ST. LUCIE PLANT UNIT NO. 1

AMENDMENT TO FACILITY OPERATING LICENSE

Amendment No. 18
License No. DPR-67

SAFETY EVALUATION BY THE OFFICE OF NUCLEAR REACTOR REGULATION

Figure 6.2-1 Offsite Organization for Facility Management and Technical Support

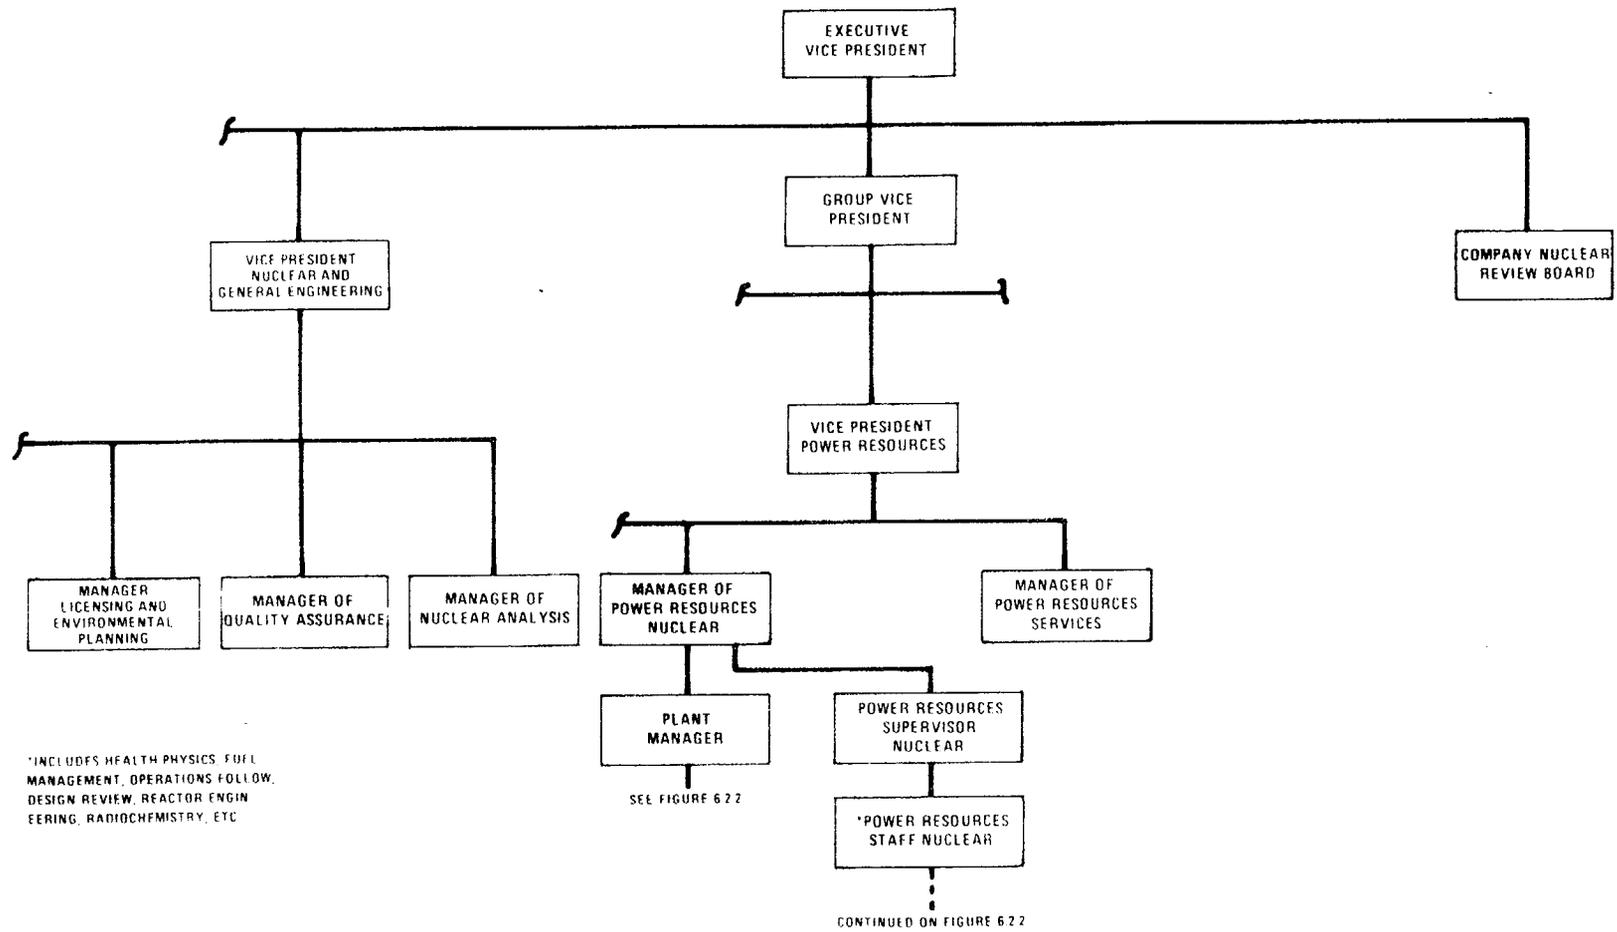
1. Modifies the Offsite Organization Chart to accommodate changes which are administrative in nature in accordance with your application dated September 6, 1977 (L-77-277),

By letter dated September 6, 1977, FPL proposed Technical Specifications changes to the Offsite Organization Chart. Proposed changes to figure 6.2-1 are as follows:

- a. New title -- Vice President
Nuclear and General Engineering
- b. New title -- Manager Licensing
and Environmental Planning
- c. Position deleted -- Vice President
Environmental Planning and Research

FPL states that the changes are not significant changes in the management or support of the FPL nuclear facilities; the responsibilities for research and environmental planning have been transferred to different people; and the changes have been reviewed by the St. Lucie Facility Review Group and the FPL Nuclear Review Board; and that the changes do not involve an unreviewed safety question.

Since the changes would not degrade operational plant safety, are administrative in nature, and would not affect the operation of either on-site or off-site safety review functions, the changes are acceptable.
